RESPONSES TO STUDY REQUESTS

WHOOPING CRANE POWER LINE IMPACT EVALUATION

RESPONSE 1.0 WHOOPING CRANE POWER LINE IMPACT EVALUATION

Loup River Hydroelectric Project location relative to whooping crane migration corridor and confirmed sightings (1950-spring 1980) in Nebraska.

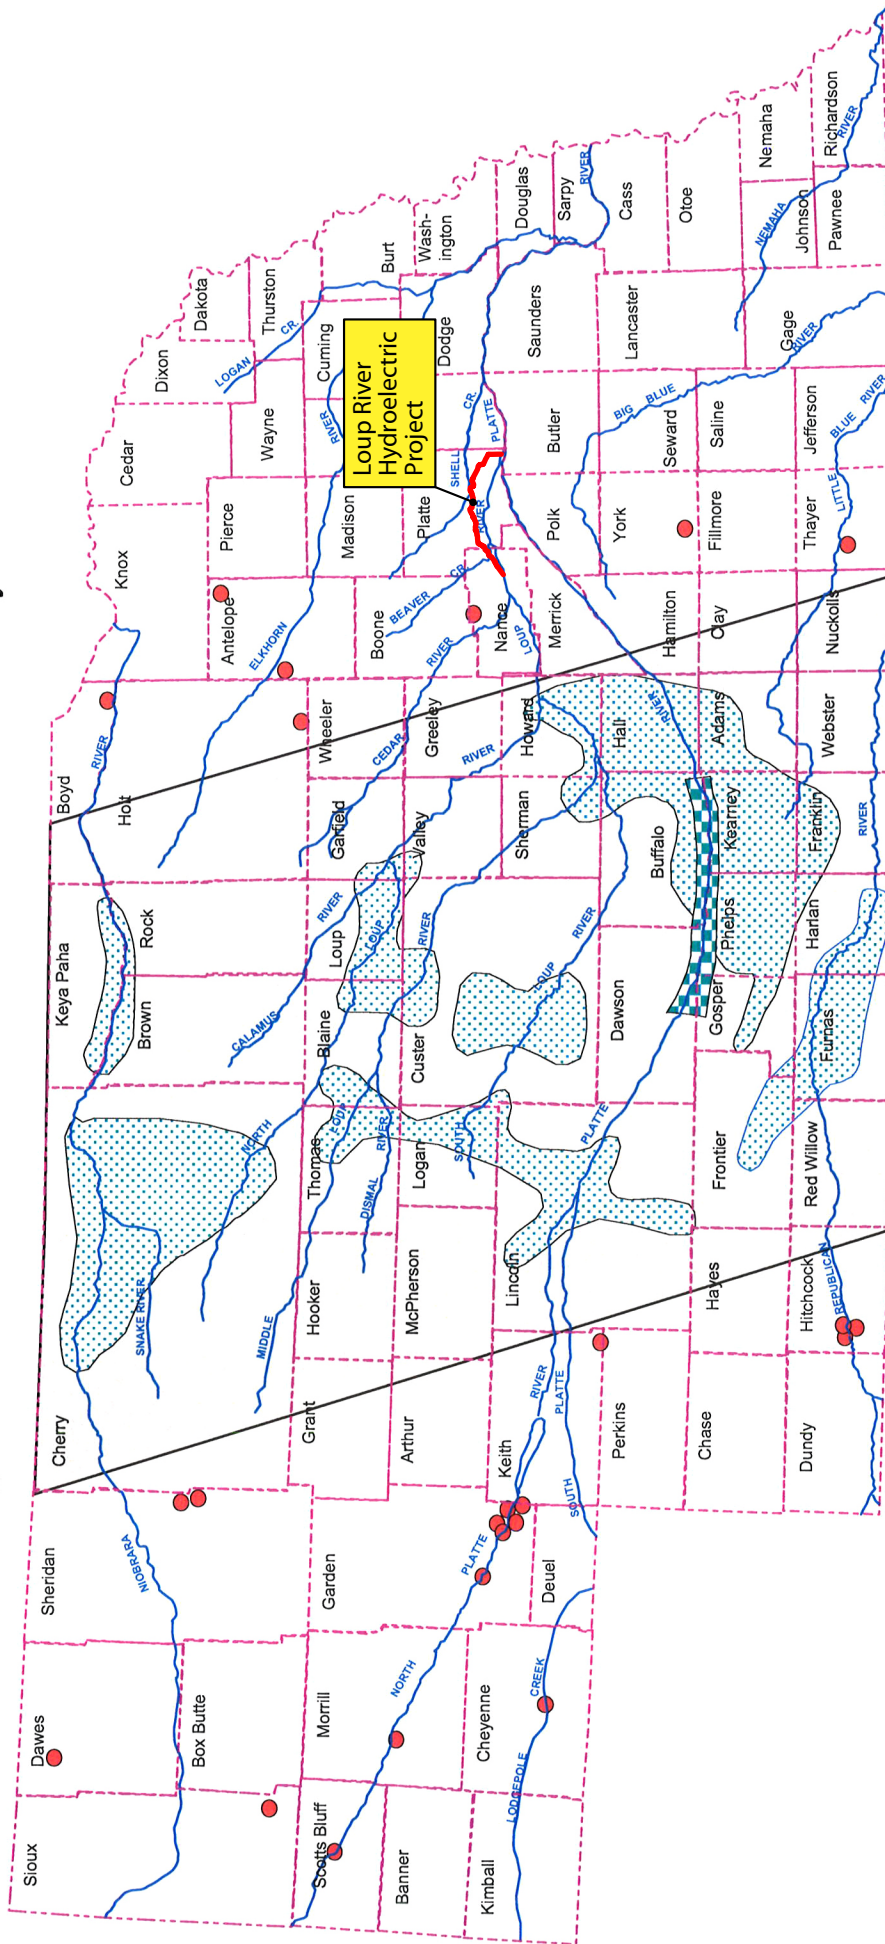
2. No whooping crane sightings have been documented within the Project Boundary. The nearest point of the Project Boundary is located approximately 35 miles east of the whooping crane's primary migration corridor,² as defined by the U.S. Geological Survey (USGS) (USGS, August 3, 2006), the Nebraska Game and Parks Commission (NGPC) (NGPC, November 2002), and USFWS (Stehn, June 1, 2007). This primary migration corridor is also referred to as the 100-mile-wide migration corridor by USFWS (Stehn, June 1, 2007). Maps showing these corridors are included at the end of this response.

The nearest point of the Project Boundary lays approximately 35 miles east of the USGS-delineated whooping crane primary migration corridor, an area in which 82 percent of all confirmed post-1949 sightings in Nebraska occur (USGS, August 3, 2006)³. USGS determined the primary migration corridor through Nebraska to be between 100 and 120 miles wide by plotting all of the confirmed sightings in the state during the last 30 years and drawing straight lines to enclose 70 to 100 percent of the sightings at each latitude (USGS, August 3, 2006). USGS goes on to state that “the remaining sightings [outside of the primary migration corridor] are primarily to the west [of the primary migration corridor].” As stated previously, the Project Boundary is 35 miles east of the primary migration corridor.

In its February 9, 2009, comment letter, USFWS states that the Project Diversion Weir lies within the migration corridor of the whooping crane. USFWS then provides the three whooping crane sightings nearest, but not within, the Project Boundary. The District provides the following clarifications to these statements:

Migration Distribution in Nebraska - February 2002

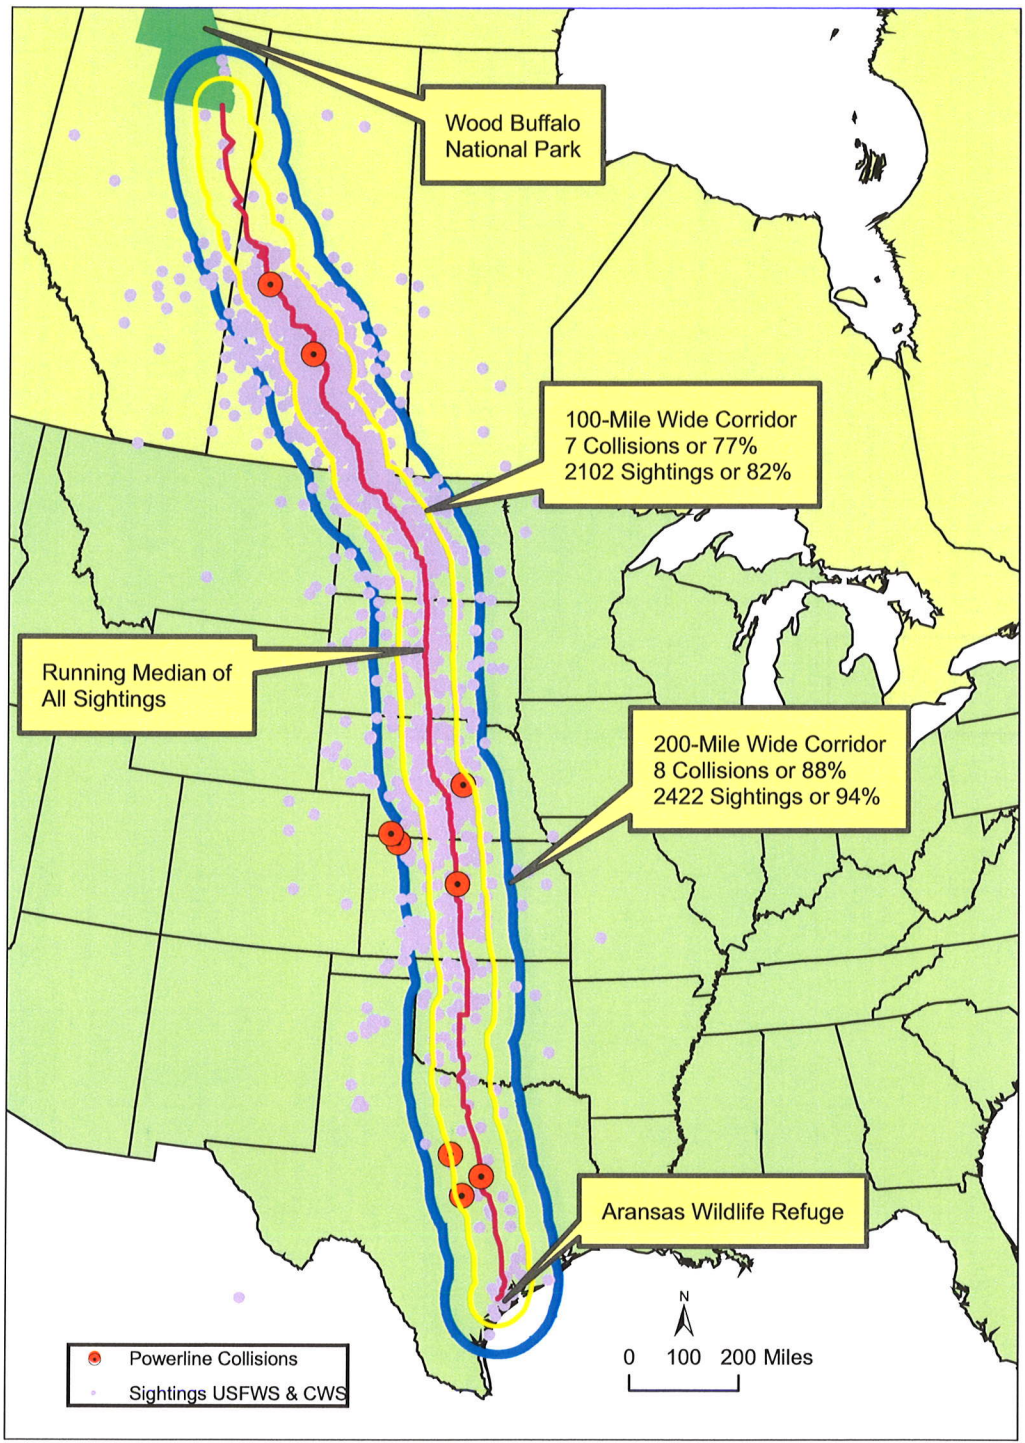
³ NGPC has delineated a primary migration corridor which is very consistent with that delineated by USGS. NGPC also states that 80 percent of confirmed sightings occur within this corridor (NGPC, February 2002).
